DESIGN REVIEW RECOMMENDATION

ADMINISTRATIVE DESIGN REVIEW

SDCI # 3036520-LU
325 NW 85th St
Seattle, WA 98117

SECTION AT ALLEY: RESPECT FROM SINGLE FAMILY ZONE STRATEGIC MODULATION FOR CLARITY OF MASSING

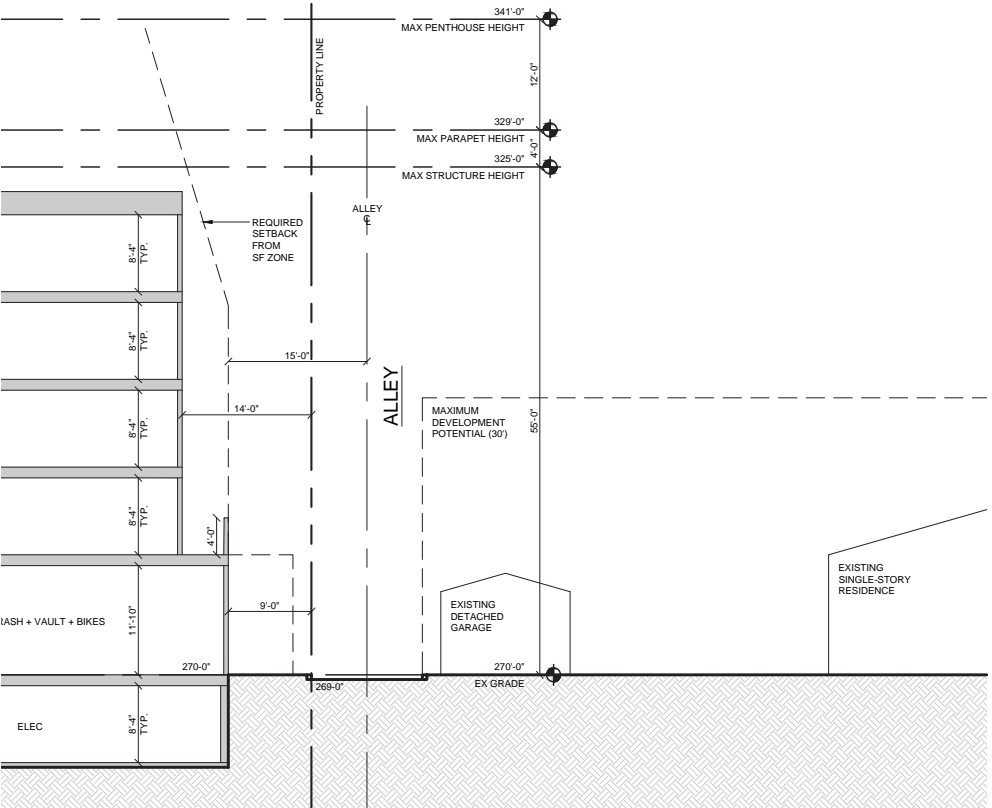
1.B. The modulation depth provided between massing elements on the south and west facades are much less than those provided on the north and east facades. Increase the depth on the south and west sides or provide reveals or other architectural moves to increase the perceived modulation depth.

APPLICANT RESPONSE:
The west facade is modulated to the maximum extent possible to maintain compliance with the building code for allowable openings and natural light requirements for Small Efficiency Dwelling Units. Beyond the 1' modulation between the northwest dark volume and remainder of the west wall, a metal siding of variable widths has been applied to the large, flat facade to create visual interest through the random pattern, and depth through shadow lines with panel recesses. Further interest has been provided on this facade with a shifting of windows within the elevation.

The south facade is designed with strategic modulation that respects the single family zone to the south and maintains an ordered, cohesive massing strategy. The southwest edge is aligned with the maximum setback at the fifth floor and continues the variable width metal siding and shifting window concept around the corner. Depth is provided at the southeast through juliet balconies and shallow metal awnings that provide both interest and depth. The ground related volume is one and half stories tall providing interest through the open metal railing as well as bio-retention planters and landscaping at the alley edge.

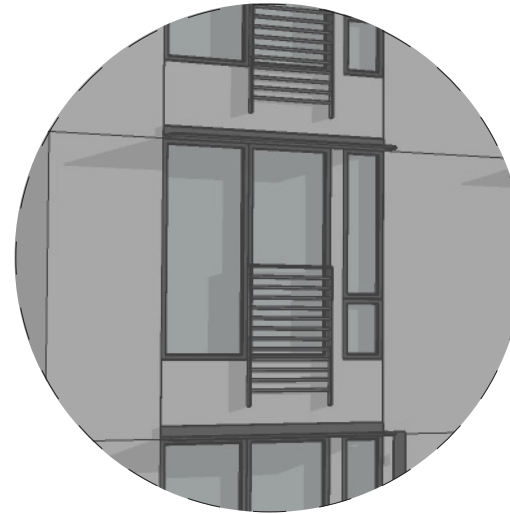
2. F. Pay special attention to the material treatment of the blank wall condition on the south side of the building as this faces the single-family zone to the south.

APPLICANT RESPONSE:

The blank wall condition at the south is mitigated by concrete planters and landscaping. A full lite door serving as a secondary entrance and likely main entrance to the bike room will allow for a connection to the building. Materials are specifically kept subdued throughout the project. Above the first floor textured materials and architectural features add scale and interest.

LIVE-WORK UNIT ENTRY: NORTHEAST VIEW

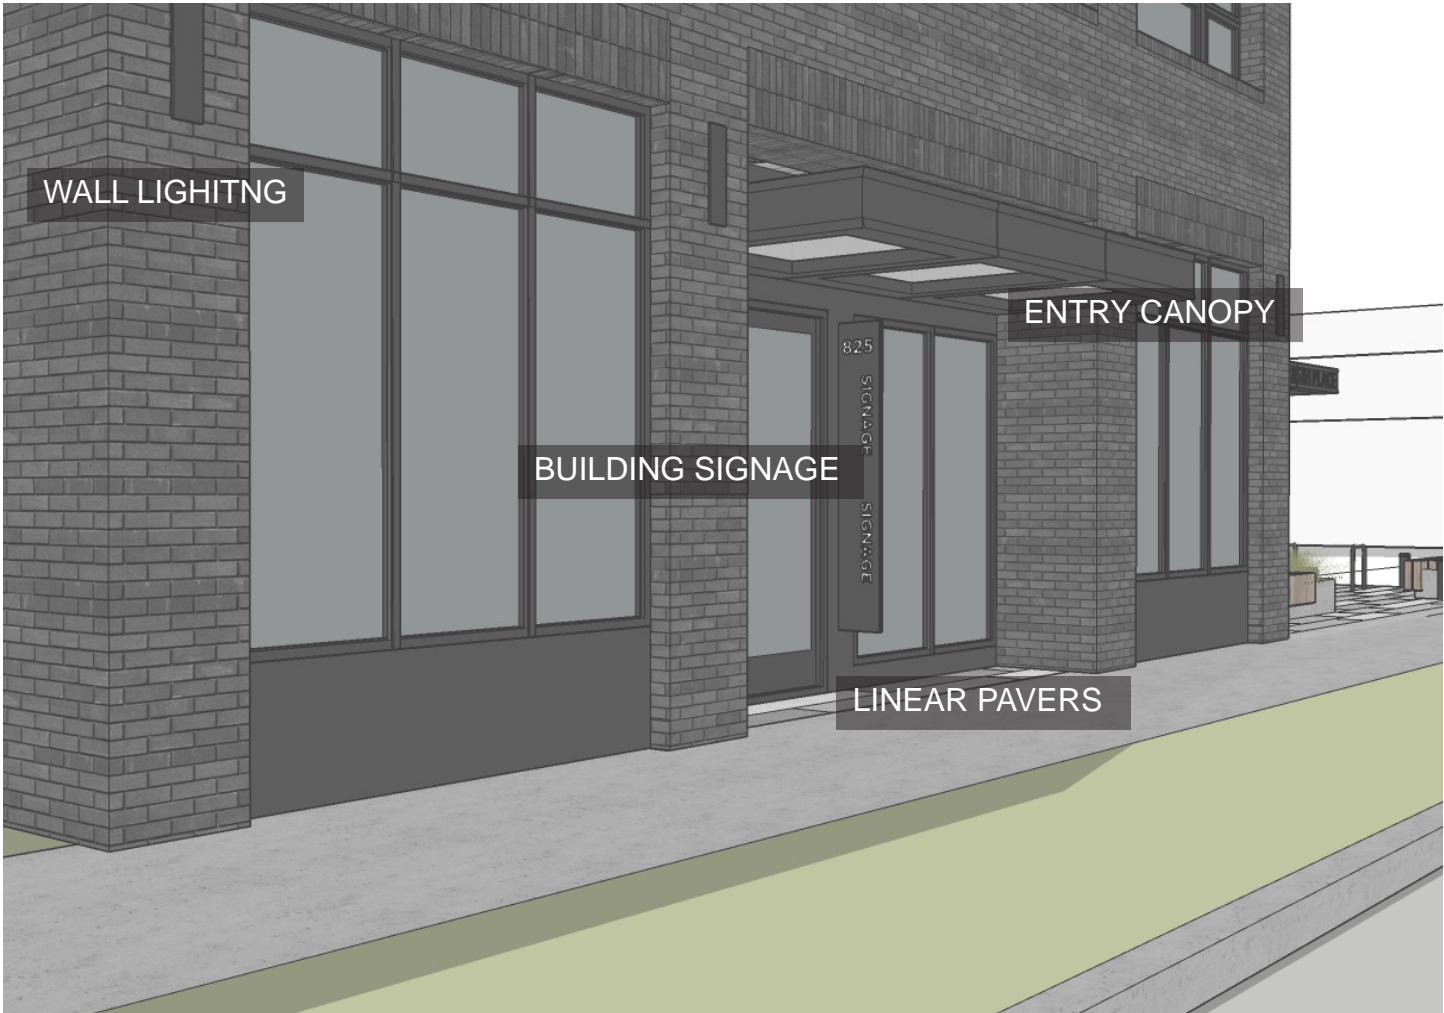
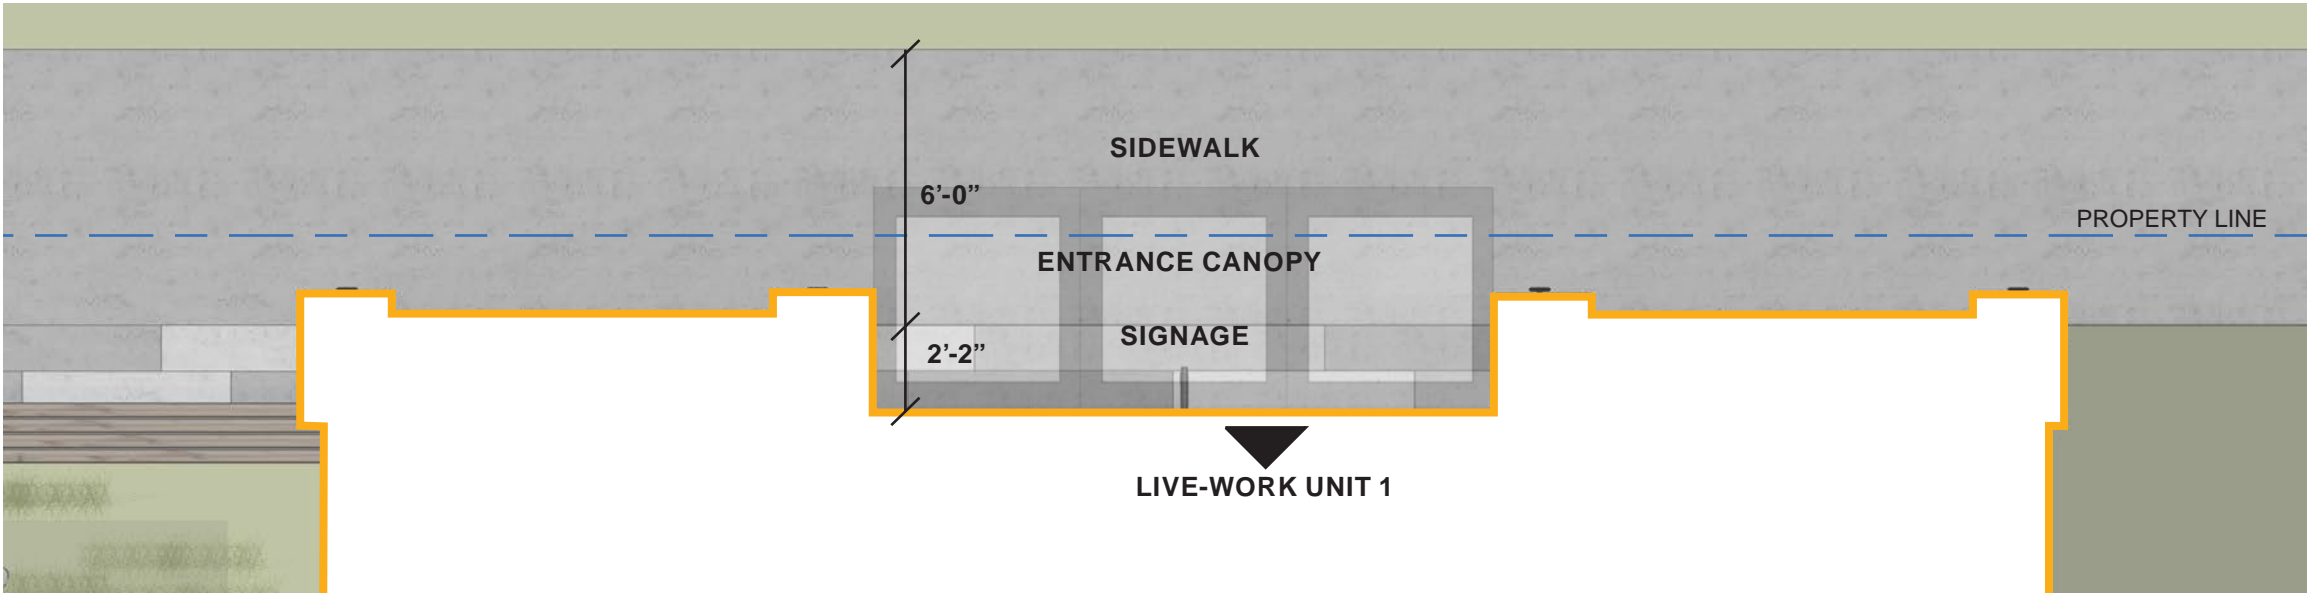
3. A. Staff is concerned with the minimal depth of the landscaping in front of the live/work units. Increase this depth to allow for appropriately scaled landscape to be planted.

APPLICANT RESPONSE:
The proposal has designed the live-work units close to the sidewalk, following the precedent of street oriented commercial development in the neighborhood. A shallow setback locates windows near the sidewalk for greater transparency into the businesses. The live-work units are designed with an opaque divider between the residential and non-residential uses, allowing the unit to open up its nonresidential front to the sidewalk. The horsetail, a tall green reed, in the shallow planters will provide a physical buffer, visual screening and interest for pedestrians.

The entries are recessed for a brief transition from the sidewalk. A material change with lighting, signage, pavers and weather protection signifies the unit entrance.

LIVE-WORK UNIT ENTRIES: NORTHEAST VIEW

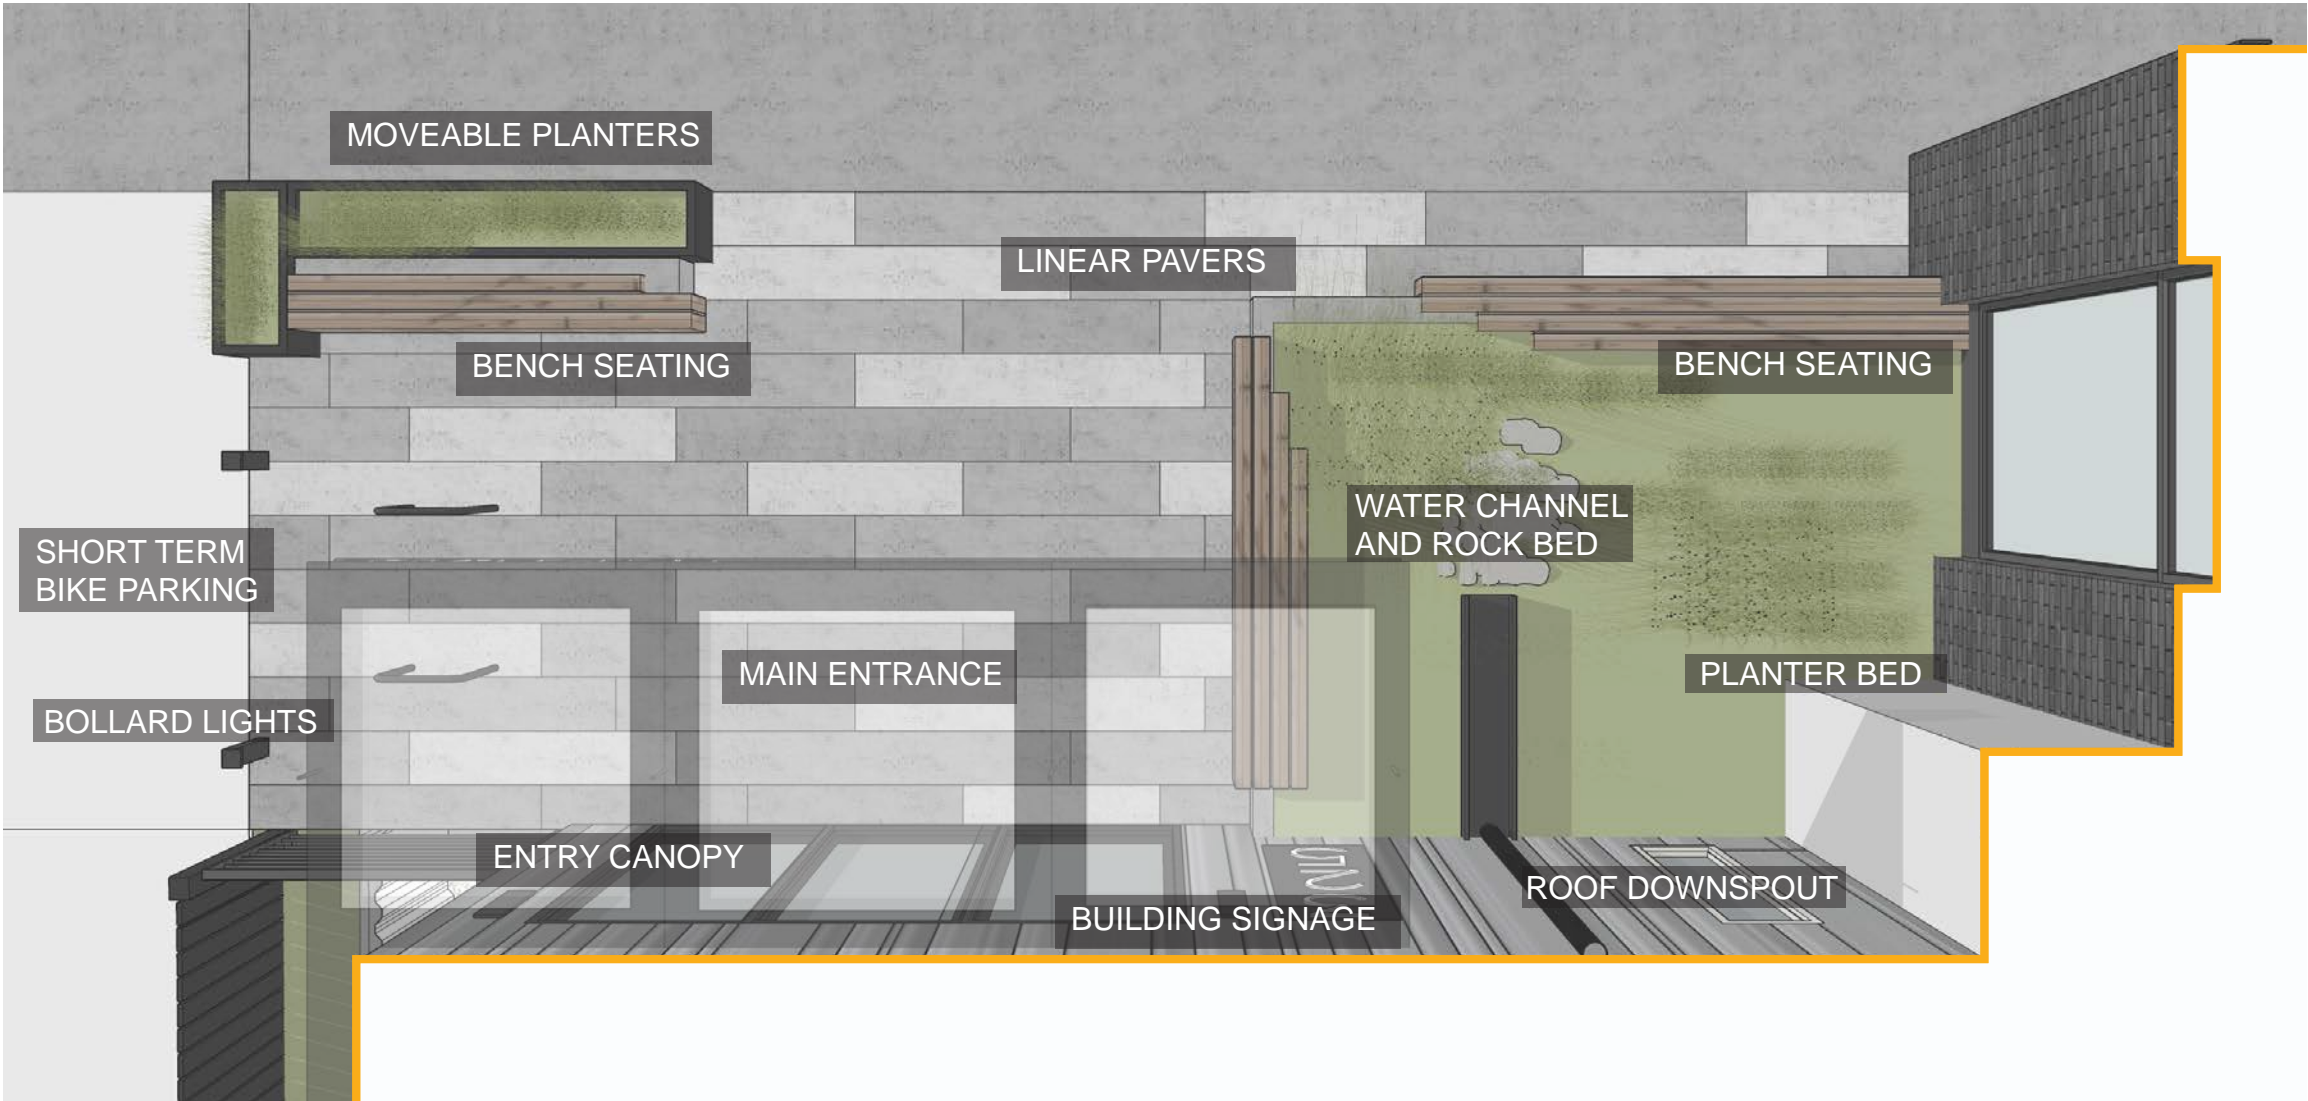
3. C. The residential lobby is set back from the sidewalk edge and will not be easily seen when approaching from the east and west. Integrate elements such as canopies, signage, bollards, or other architectural features that will help enhance the entry sequence and wayfinding. Staff also recommends providing more transparency at the corner of the west live/work unit to provide visibility through to the residential lobby.

APPLICANT RESPONSE:
The entry sequence has been designed as a transition zone between the sidewalk and the entry as a place for spontaneous interaction. A bench surrounded by planters anchors the northwest corner of the entry plaza. Canopy and building related signage signify the entry and a combination of down lighting, wall sconces and planter accent lights will create soft, but clear wayfinding cues from the sidewalk.

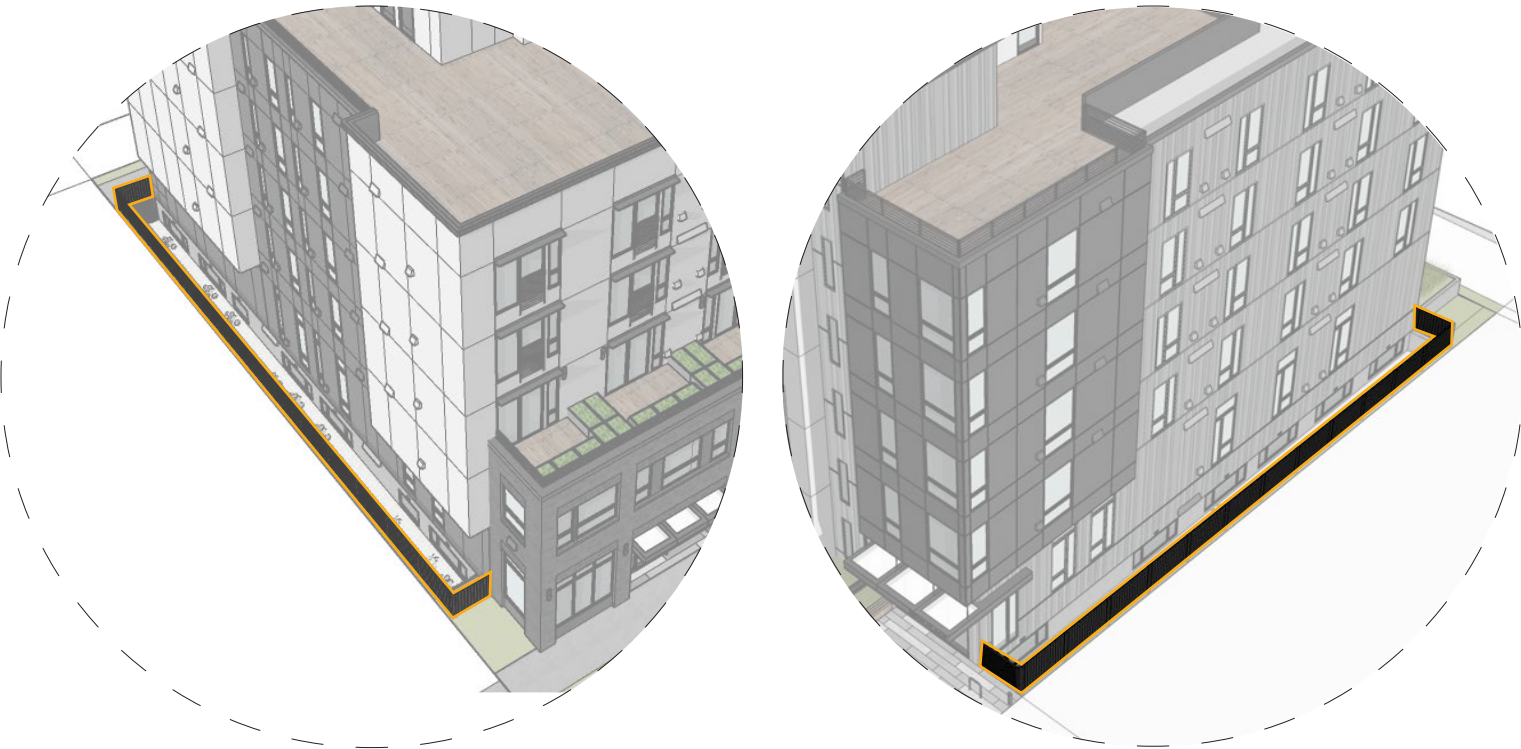
3. E. Staff is concerned that the location of building services and the bike room along the alley will create a blank wall condition. Study providing more active uses along the alley such as: orienting residential units toward the alley, similar to Option 1, and moving the bike room to a more interior location;or providing a residential amenity space in front of the bike room that could take advantage of the landscape within the setback.

APPLICANT RESPONSE:
The bike room remains at the southwest corner, serving as a transition from the public alley to the private units. A transparent door indicates the secondary building entry, providing a line of site between the alley and building interior. Signage will indicate that bike parking is best accessed from the alley. A bench outside the entry and partially under cover provides a small amenity space for residents. With the location of the bike room adjacent to this entrance on the interior, cyclists, for example, can stop, decompress, take off their helmet and cycling shoes before storing their bike away. The ground level alley facade was designed with similar features as the street facing facade, incorporating elements such as planters, bench seating, entrance canopies, lighting and signage. The dark siding and single story volume is mimicking the brick volume at the street and continuing the massing to the rear. Ultimately the design aims to keep the alley facade quiet, literally and figuratively, to respect the single family homes to the south.

FENCE LOCATIONS IN PLAN

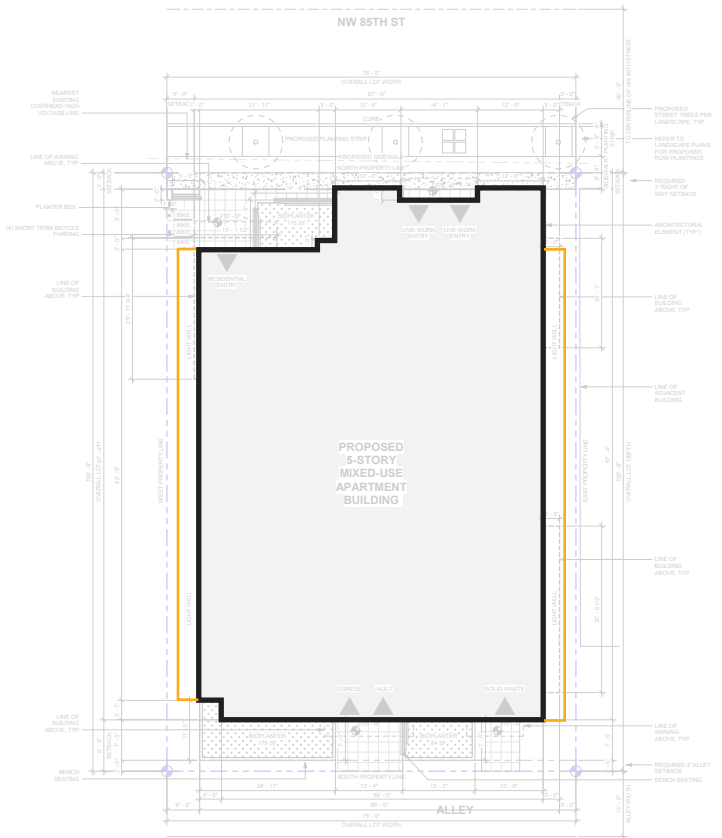
3. F. It is unclear whether fencing is proposed along the east and west property lines, or if gates and fencing will be proposed along the street and alley. Design any fencing and gates to coordinate with the architectural concept of the building and landscape design.

APPLICANT RESPONSE:
Fencing is proposed along the east and west property lines. Gates will be provided for restricted access for maintenance of the window wells.
